From: [Sarah Grice](#)
To: [Mark Ewbank](#)
Cc: [Erickson, Vivian \(Consultant\)](#); [Fieser, Aaron \(Consultant\)](#); [Logan Dougherty](#)
Subject: FW: WSDOT SR 167 Completion project - preliminary design of a replaced storm drain outfall through river bank revetment near Meridian Avenue bridge
Date: Tuesday, June 6, 2023 10:59:52 AM
Attachments: [image001.png](#)
[image002.png](#)
[image003.png](#)
[SR167 Puyallup Outfall Profile.pdf](#)

From: Mark Ewbank <mewbank@herrerainc.com>
Sent: Monday, June 5, 2023 4:33 PM
To: Sarah Grice <sarah.grice@piercecounitywa.gov>
Cc: Erickson, Vivian (Consultant) <ErickVi@consultant.wsdot.wa.gov>; Fieser, Aaron (Consultant) <fiesera@consultant.wsdot.wa.gov>; Logan Dougherty <ldougherty@HNTB.com>
Subject: WSDOT SR 167 Completion project - preliminary design of a replaced storm drain outfall through river bank revetment near Meridian Avenue bridge

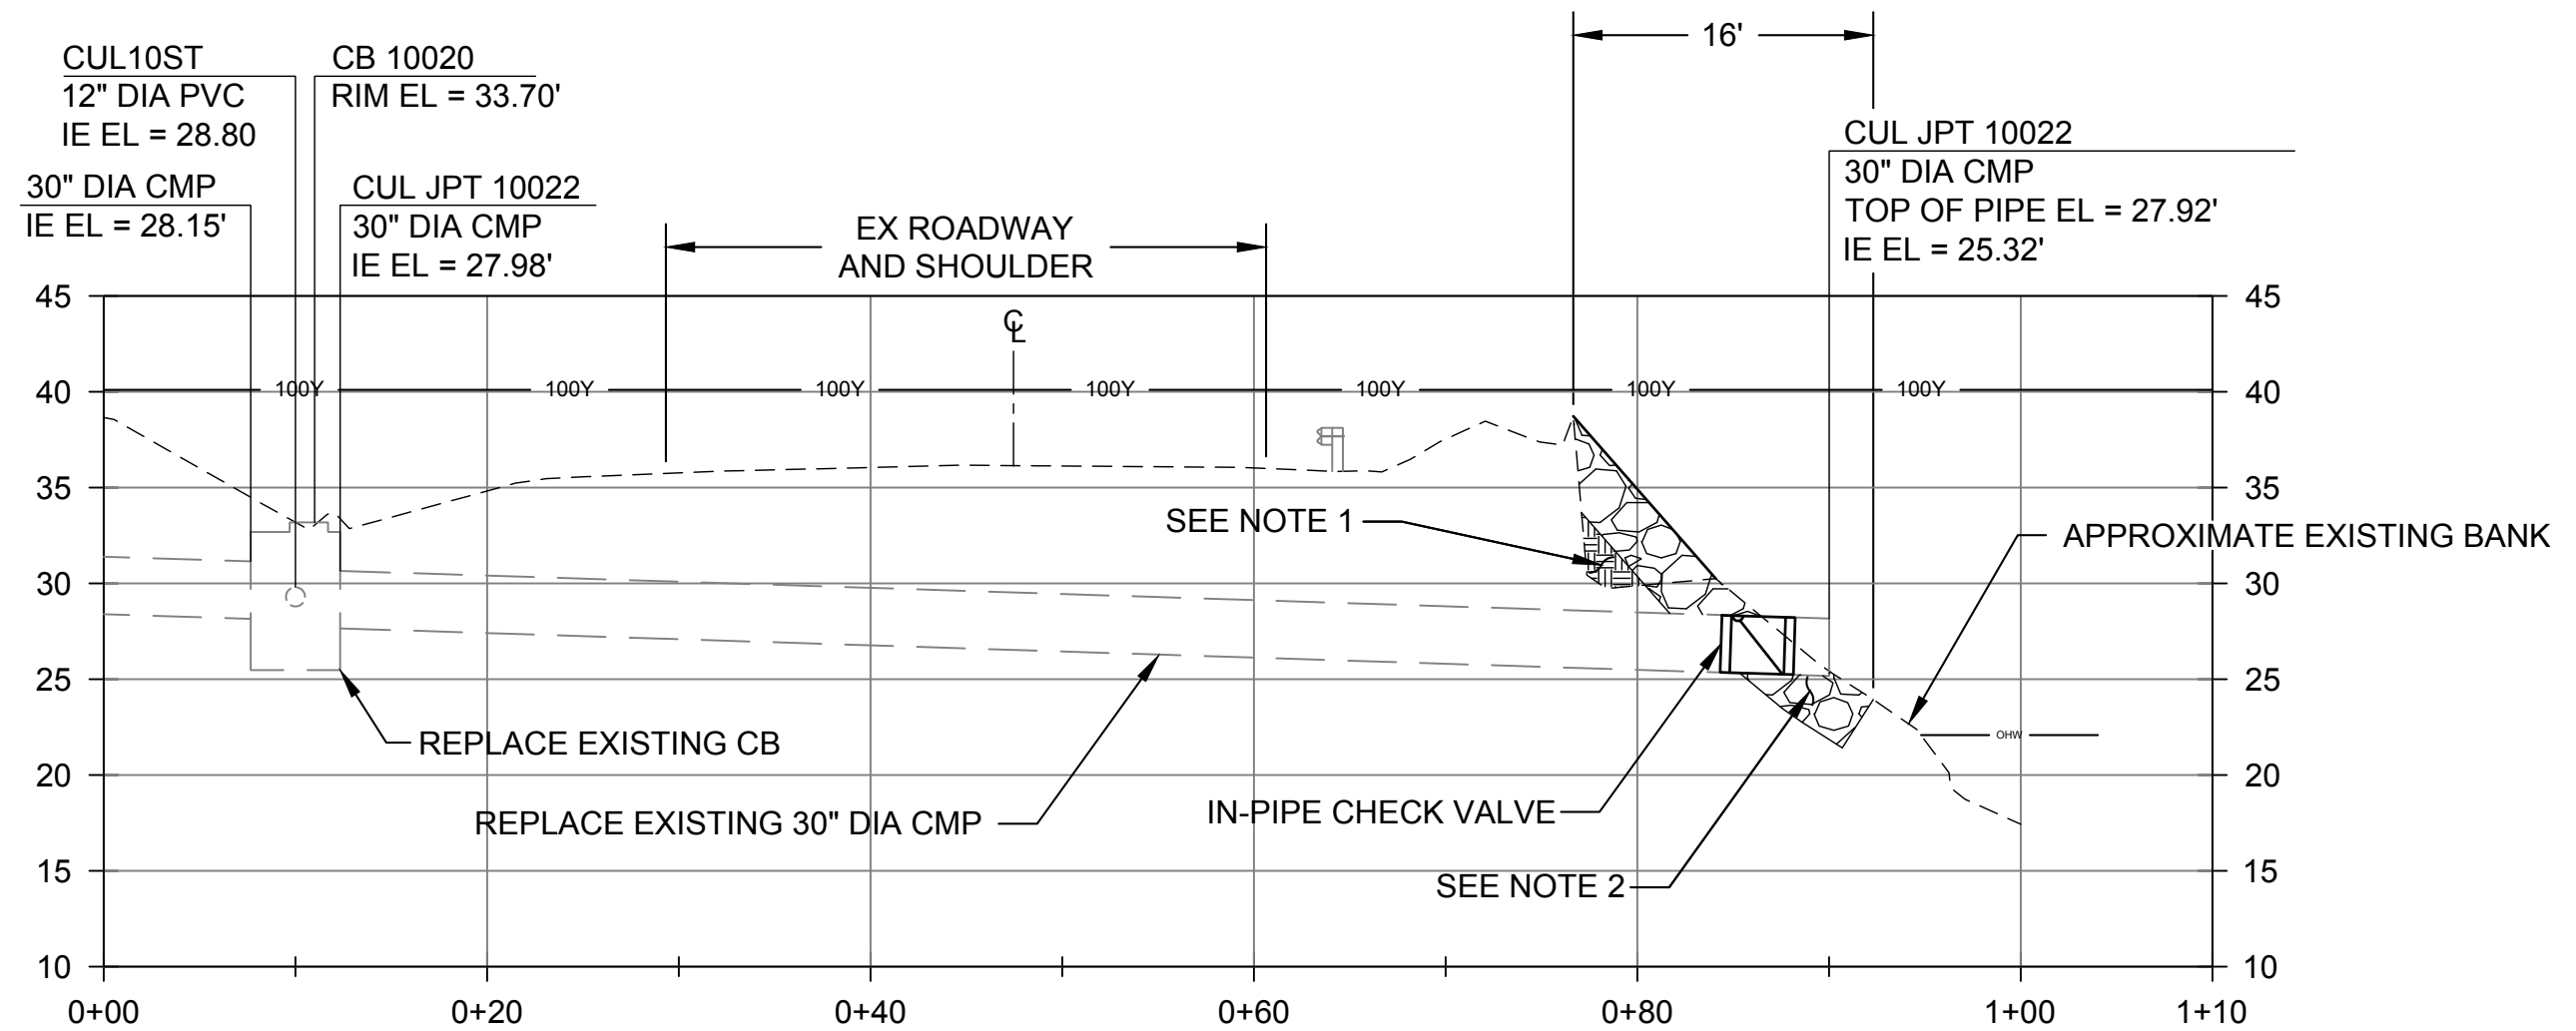
We find the attached detail to be acceptable for the replacement of outfall, as it will closely match pre-project levee conditions.

We shared the attached outfall design profile with Russ Ladley of the Puyallup Tribe of Indians and Miles Penk of WDFW, and neither of them requested any changes to it. Miles told us he will include this outfall in the HPA he writes for WSDOT's SR 167 Stage 2 project because flows emanating from it can potentially affect the river bank below OHWM (downslope of the new outfall pipe). The outfall location is shown in the image below. We attempted to emulate revetment re-construction around the new pipe based on the drawing you sent to me several months ago for the nearby Murphy Revetment repair project.

This design configuration includes a check valve in the pipe interior to prevent fish from swimming upstream in the pipe (and prevent river water from going upstream in the storm drain system when at flood stage). That feature was a request from Russ Ladley that he voiced several months ago, before we prepared this profile.

As part of City of Puyallup shoreline permit approval, the City needs confirmation that this outfall design is acceptable to Pierce County. And thus we seek that confirmation from you, or otherwise we need to understand design revisions that are necessary in order for Pierce County to endorse it.
